COMMENTS AND RESPONSES

GROUNDWATER PUMPING/WATER TRANSFER PROJECT
FOR 25 CONSECUTIVE YEARS

OCTOBER 3, 2007

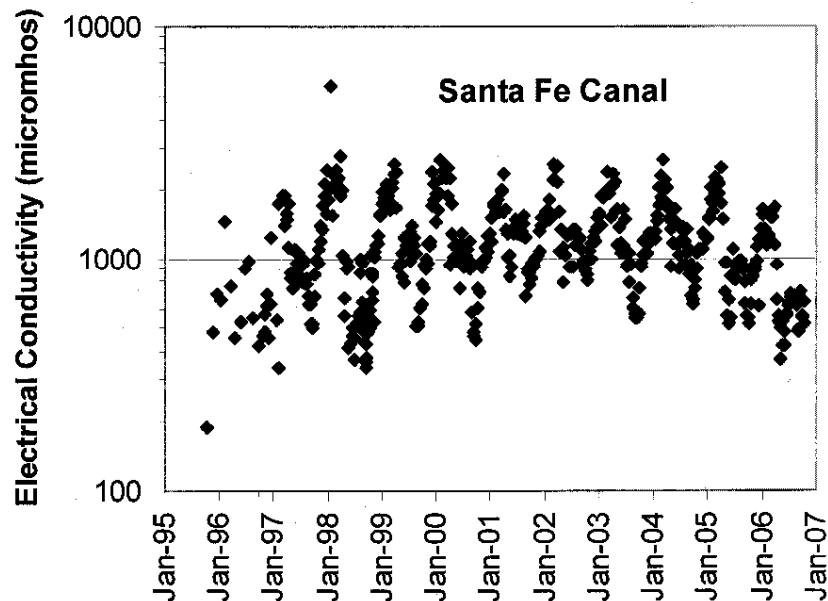
Refuge water supplies from the Outside and Main Canals are further degraded by the time they reach Refuge units as shown in Figure 1.

12 As denoted in the EA/IS, the proposed action is expected to lessen water quality in the Main Canal (the supply source to some wildlife management areas in the Grasslands) by 30 to 70 uS/cm EC during March through October of non-critical years and up to 90 uS/cm EC during critical years (equating to roughly an 8-12% increase in EC/TDS concentrations). A TDS increase of 8 to 12 % in the Main Canal would cascade through the delivery systems resulting in an increase of TDS delivered to Refuge units which already receive water at and above water quality standards.

**FIGURE 1-LOCATION OF SUBSURFACE
GEOLOGIC CROSS SECTION C-C'**

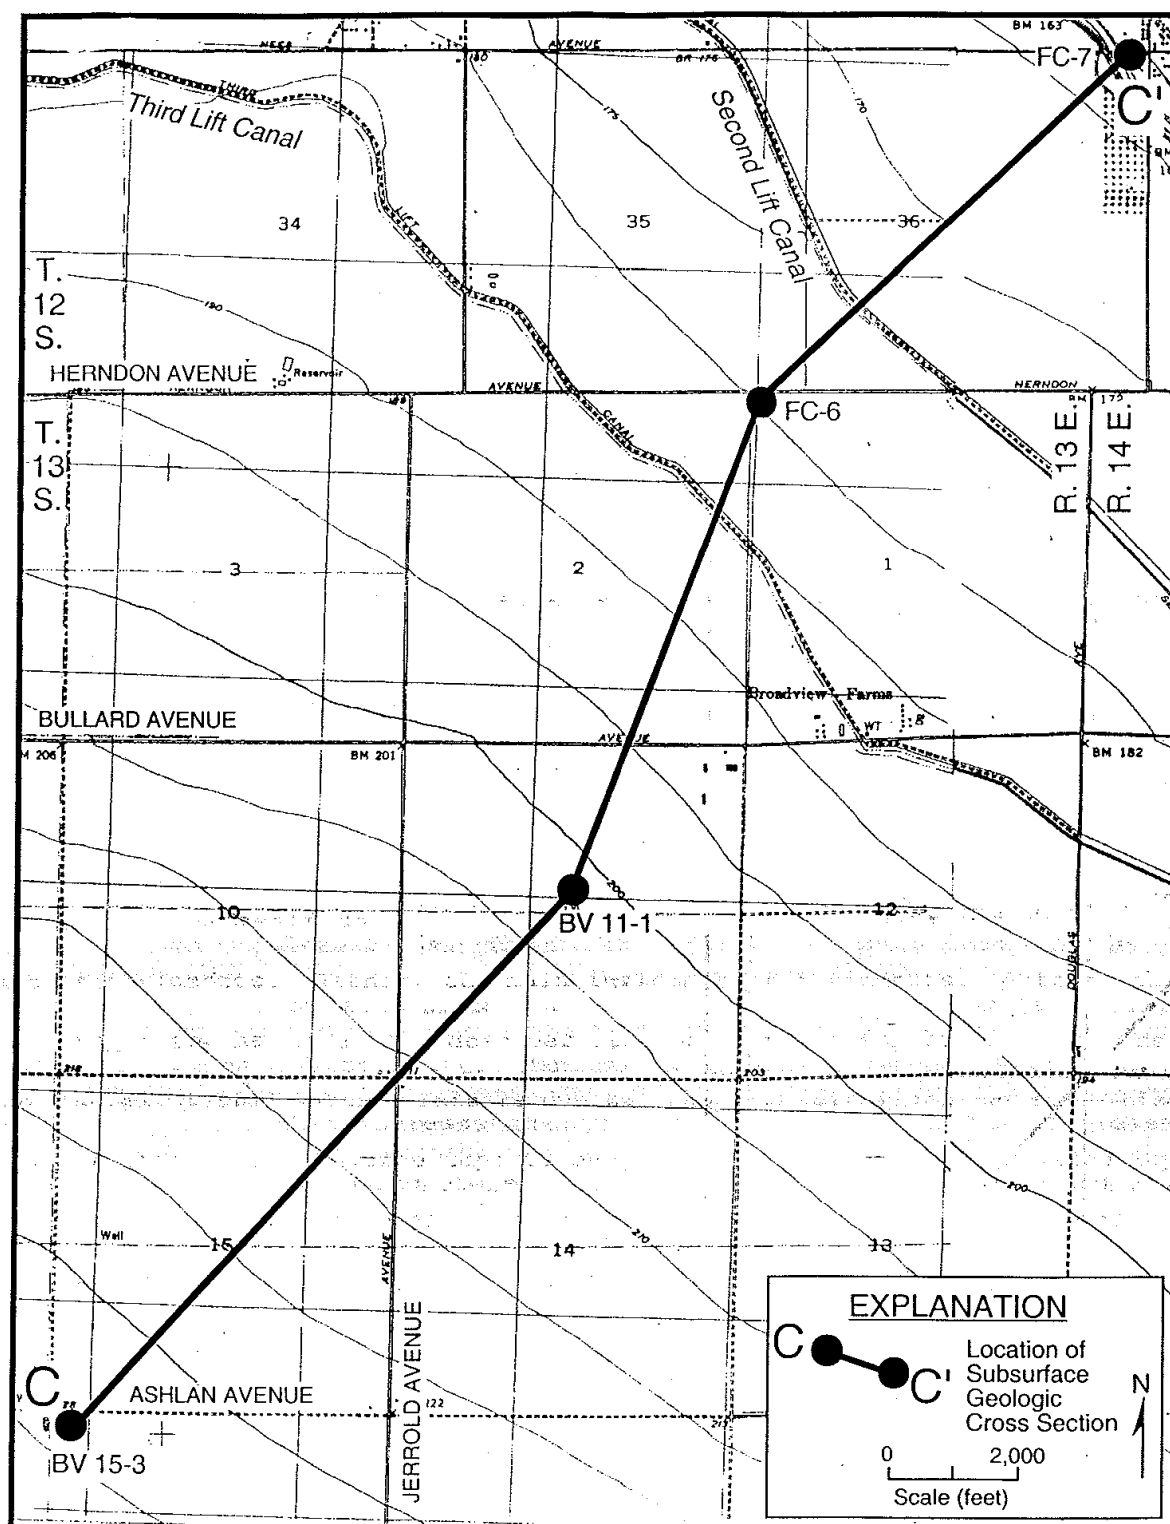
1 **The project does not adequately consider groundwater quality degradation.** Section 3.4.1.5 describes how the aquifer characteristics change with depth. Pumping from this aquifer (above the Corcoran clay) will likely result in drawdown of the water currently near the surface, causing additional salts and other materials currently present at shallower depths to migrate deeper. If this is the case, mitigation measures should be evaluated and implemented where feasible. At the very least, if this alternative is implemented, monitoring wells should be used to track both vertical and horizontal migration of constituents of concern (salts, selenium, others?) in the groundwater table.

Subsurface geologic conditions are important in evaluating the potential for downward flow of shallow groundwater. KDSA (Figure 2, 2006) indicated that predominantly fine-grained Coast Range alluvium in the study area was about 25 feet thick near the east edge of Subsurface Geologic Cross Section A-A' and about 140 feet thick near the west edge of this section. A number of test holes have been drilled into these shallow Coast Range deposits, primarily for monitoring purposes. Normally these deposits are predominantly clay to the total depth, with several interbedded relatively thin sand layers. While the sand layers have high hydraulic conductivities and readily convey groundwater laterally to downgradient areas, the low vertical hydraulic conductivities of the thicker interbedded clay layers greatly retard the downward flow of ground-water.

Besides the fine-grained Coast Range deposits, another confining bed is present in the east part of the study area (KDSA, 2006). This is a clay layer normally about 70 feet deep that is termed the A-clay. This clay also retards the downward flow of shallow groundwater into the underlying Sierran sands. The A-clay has been studied in detail in the vicinity of the Mendota Pool (KDSA and Luhdorff & Scalmanini annual monitoring reports on the Mendota Pool Pumpers project).

Additional mitigation measures would be incorporated into the project to minimize the downward flow of shallow groundwater. First, the tops of the recovery well perforations would be placed below a depth of 150 feet (i.e., far below the base of the confining beds). The exact well design will be based on the results of electric logging either a test hole or pilot hole prior to construction of each well. The wells are to be designed to tap lower salinity water in the profile below a depth of about 150 feet and above the Corcoran Clay, as opposed to shallower poor quality groundwater. Second, the proposed pumping rate is close to that of the projected lateral groundwater flow in these strata. This in itself would minimize the downward flow of shallow groundwater. Third, groundwater monitoring using existing monitor wells can be used to evaluate changes in downward flow. In the 1980s and the late 1990s, a number of shallow monitor wells were installed by the Four Entities (predecessors of the Exchange Contractors) at three sites in the area upslope of the project. These wells tap permeable sand layers in the Coast Range deposits above a depth of about 50 feet. More recently, the Exchange Contractors installed another series of monitor wells, which extend deeper. The attached Figure 1, shows the locations of these monitor wells. Monitoring of the following wells would be incorporated into the project:
